SNHD-21ITB004 Construction Services Lab Expansion
Addendum #1 - Questions and Answers, issued 07/23/2021

REVISED DOOR SCHEDULE DURING BIDDING

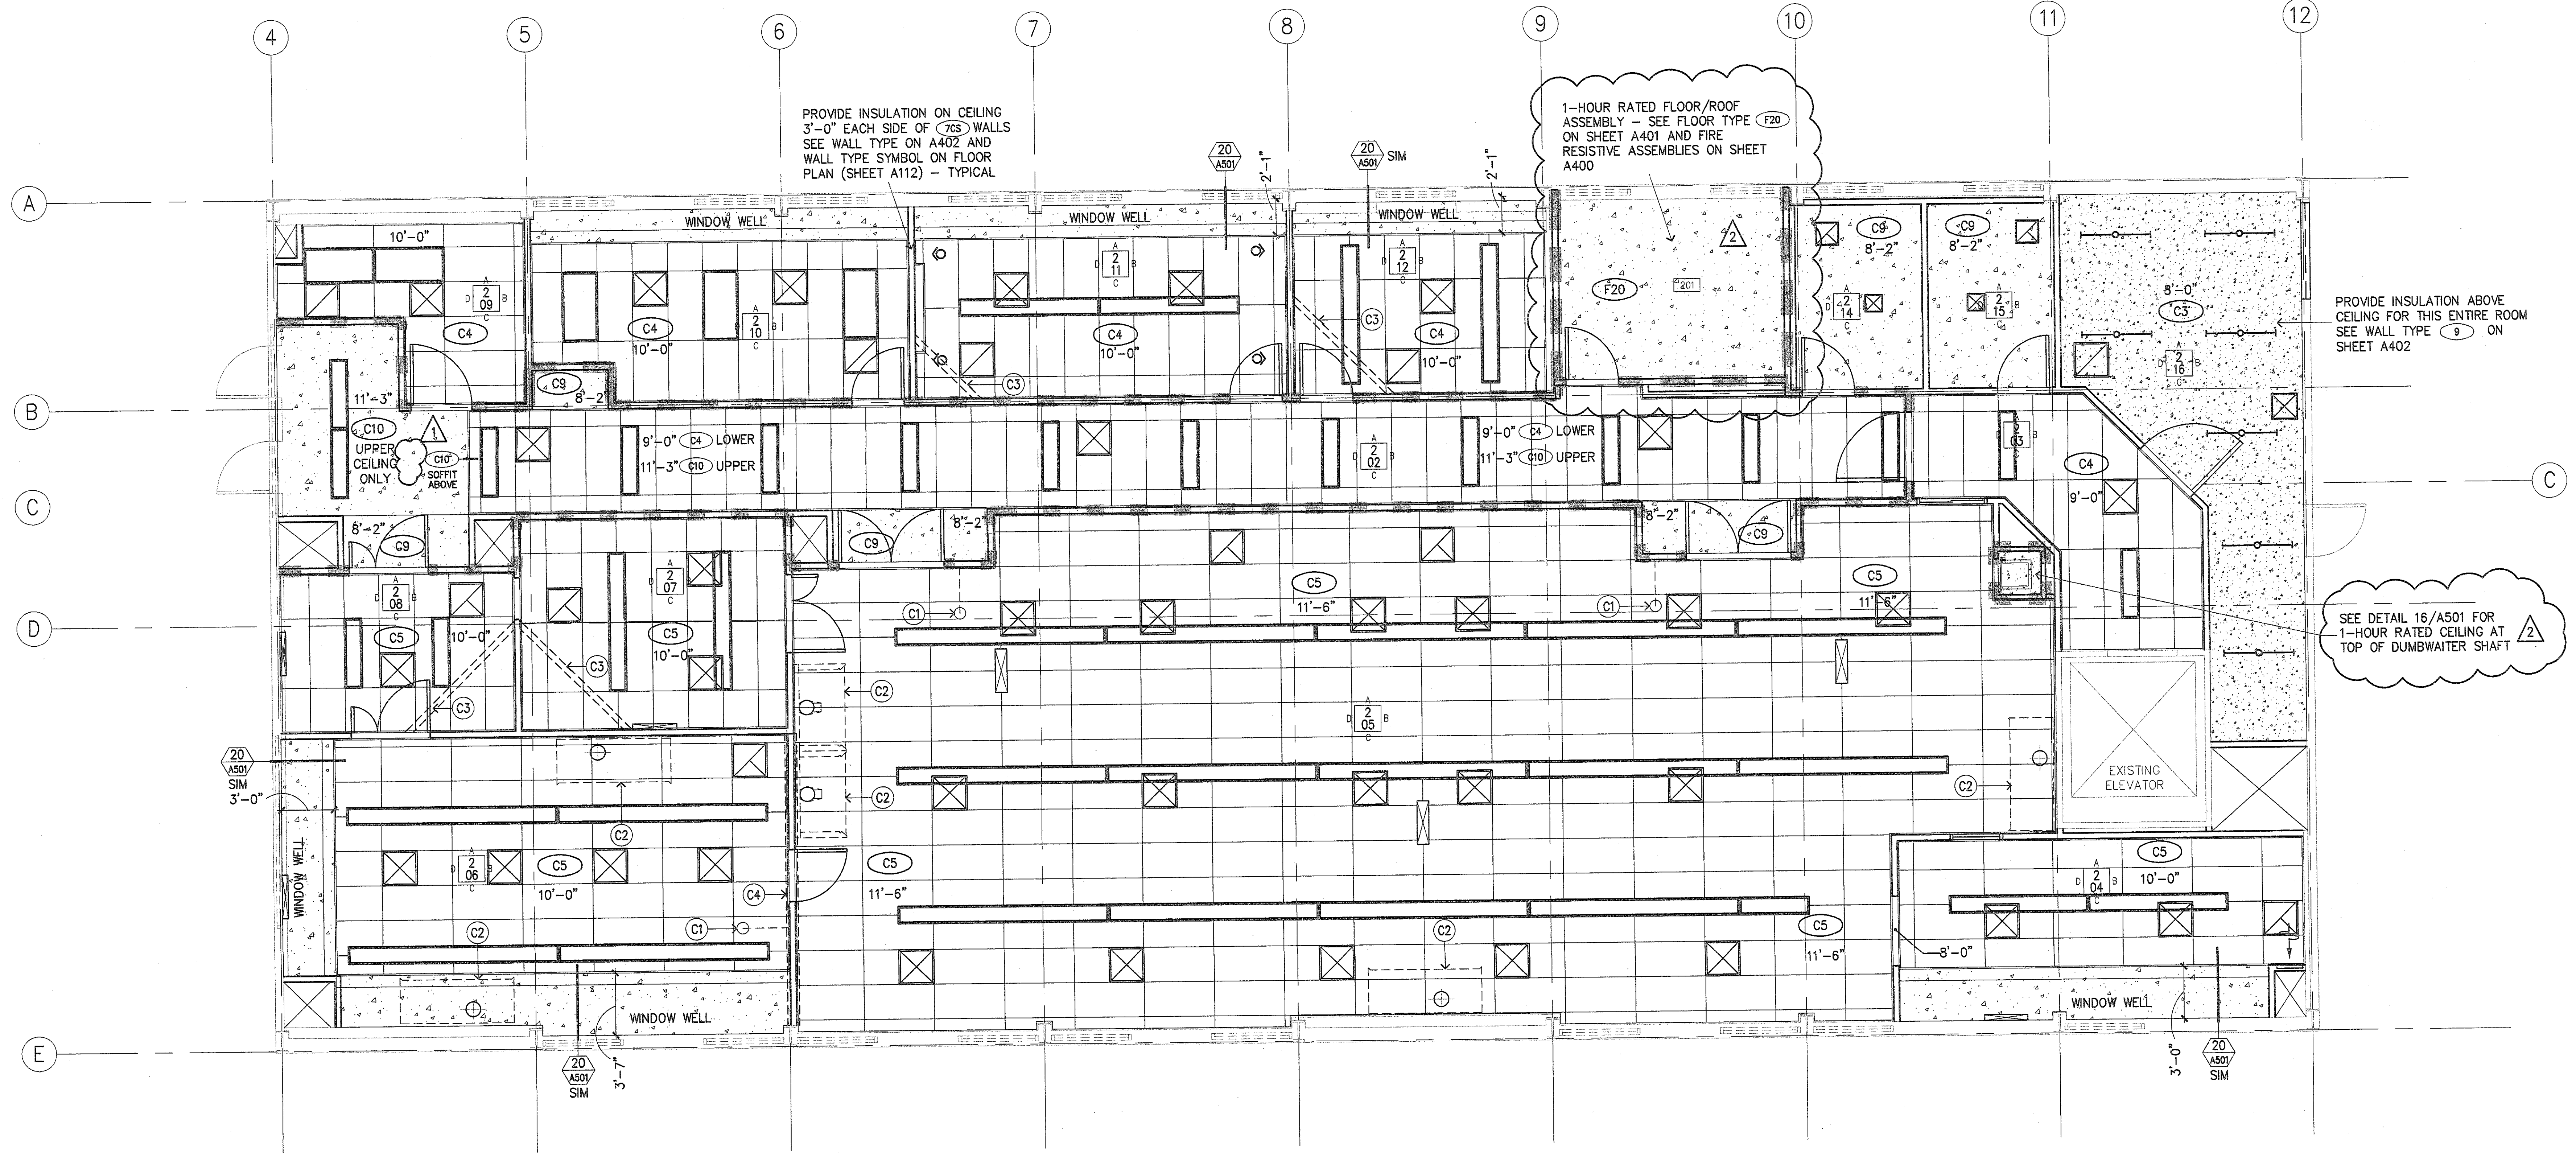
BU-13	7/9/2021 8:21 AM	On the door schedule on A150, it calls for doors listed as door type A to receive a ST-1 finish, but the finish legend does not define what ST-1 is. What is ST-1; stone, paint, etc?	Please see attached revised door schedule SK-1.
BU-14	7/9/2021 8:21 AM	On the door hardware set on A150, it calls for hardware set 01CR to have a card reader that is to be by the security contractor, who is the security contractor you would like us to use?	The card reader will be installed by SNHD staff. Please provide box with pull string.

NUMBER	PAIR	W	H	T	DOOR TYPE	DOOR MATL.	DOOR FINISH	FIRE RATING	FRAME TYPE	FRAME MATL.	FRAME FINISH	HARDWARE	REMARKS
143A		4' - 0"	7' - 0"	0' - 1 3/4"	B	SC/GL	PL		1	KD	PT - 2	01CR	PROVIDE CARD READER
143B		4' - 0"	7' - 0"	0' - 1 3/4"	B	SC/GL	PL		1	KD	PT - 2	01CR	PROVIDE CARD READER
144		3' - 0"	7' - 0"	0' - 1 3/4"	C	SC/GL	PL		1	KD	PT - 2	01	
145		3' - 0"	7' - 0"	0' - 1 3/4"	A	SC/WD	PL		1	KD	PT - 2	02	
146		3' - 0"	7' - 0"	0' - 1 3/4"	A	SC/WD	PL		1	KD	PT - 2	02	
147		3' - 0"	7' - 0"	0' - 1 3/4"	A	SC/WD	PL		1	KD	PT - 2	03	
148		3' - 0"	7' - 0"	0' - 1 3/4"	A	SC/WD	PL		1	KD	PT - 2	03	
149		3' - 0"	7' - 0"	0' - 1 3/4"	A	SC/WD	PL		1	KD	PT - 2	04

FIRST FLOOR REFLECTED CEILING PLAN (PARTIAL PLAN)
1/4" = 1'-0"
0 2 4 6 8 10 12

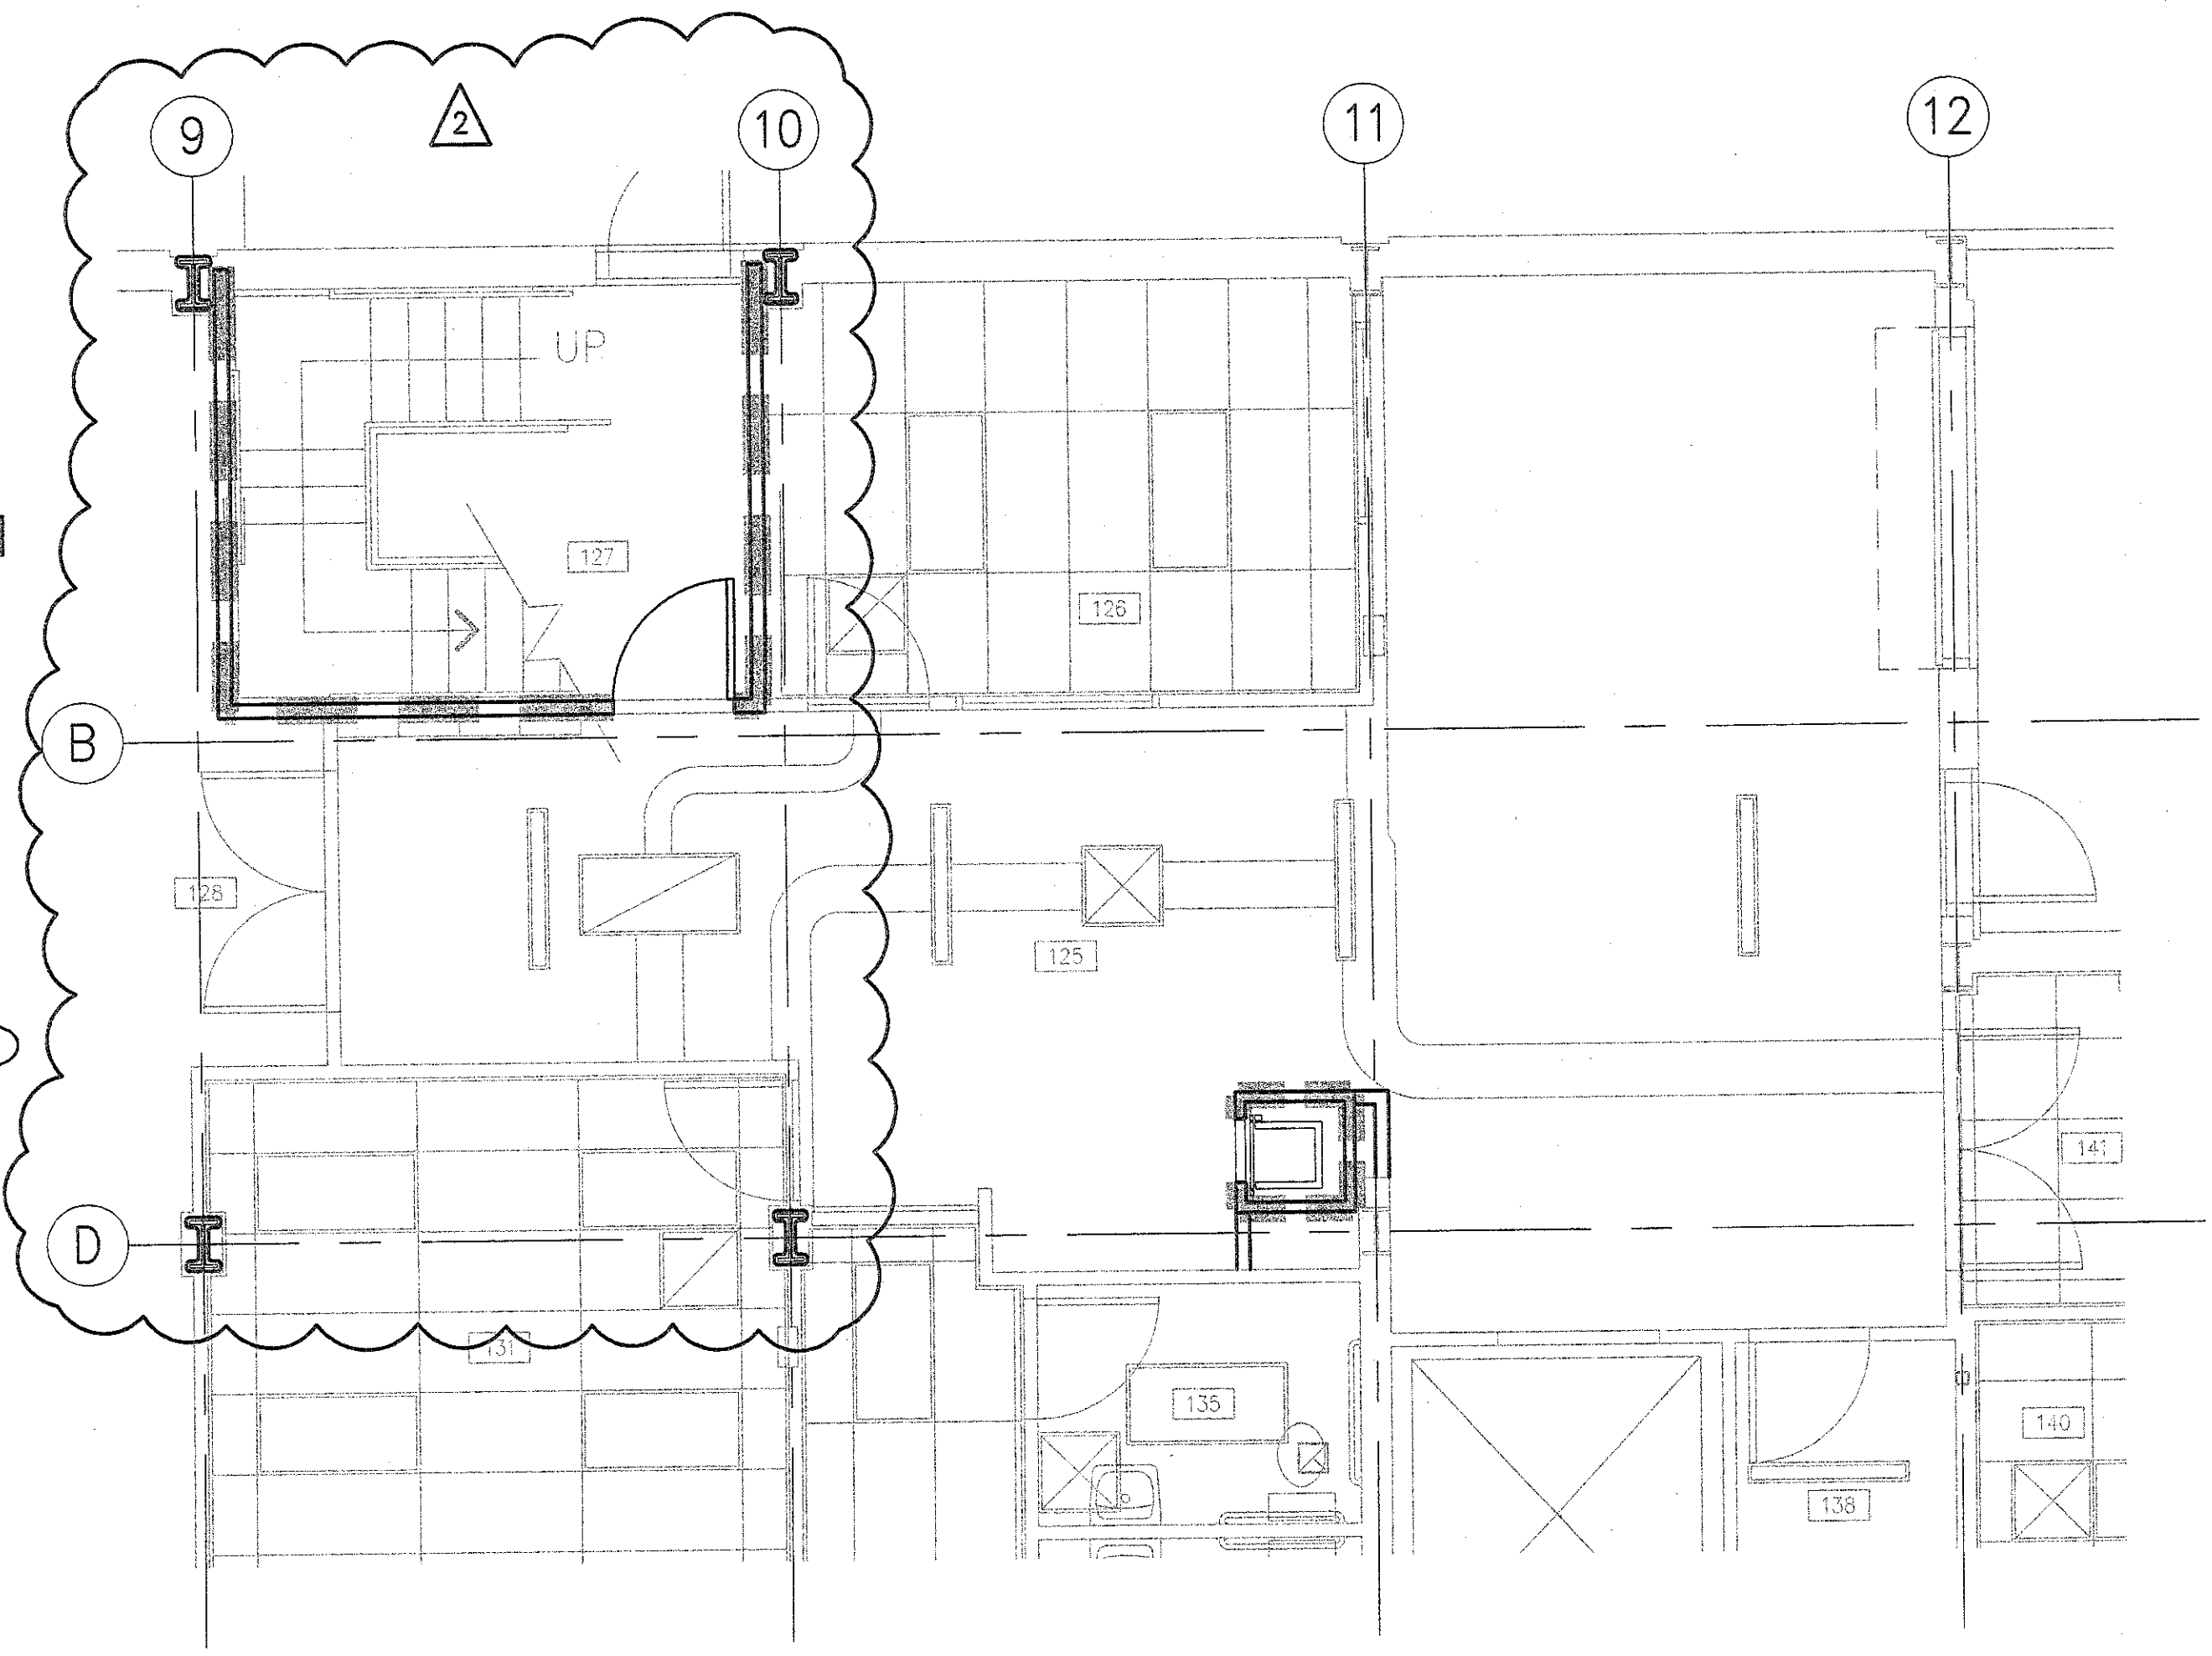
BU-17	7/9/2021 8:21 AM	Please provide RCP of second floor as well so GC can know what to patch back when bringing power from panel on second floor to first floor (if necessary) and what to patch back when removing RTU and doing associated mechanical work on second floor.	Architecturally, there is no work at the second floor RCP. Electrical engineer's response: There is an electrical connection to a panel in the Storage Room on the second floor. This new feeder should drop down through the floor and I don't see where there will be any impacts with the second floor ceiling. M&P engineer's response: There is no mechanical or plumbing scope on the second floor. All roof work occurs on the low roof and does not pass through level 2.
BU-18	7/9/2021 8:21 AM	On sheet A300, the hot lab is being called for ACT-2, yet the pattern that is around it looks like ACT-1. Which type of ceiling will be used in the Hot Lab (room 144)?	There is no pattern difference between ACT-1 and ACT-2. They are both 2x4 tiles. Hot Lab ceiling will be ACT-2, see finish tag on RCP.
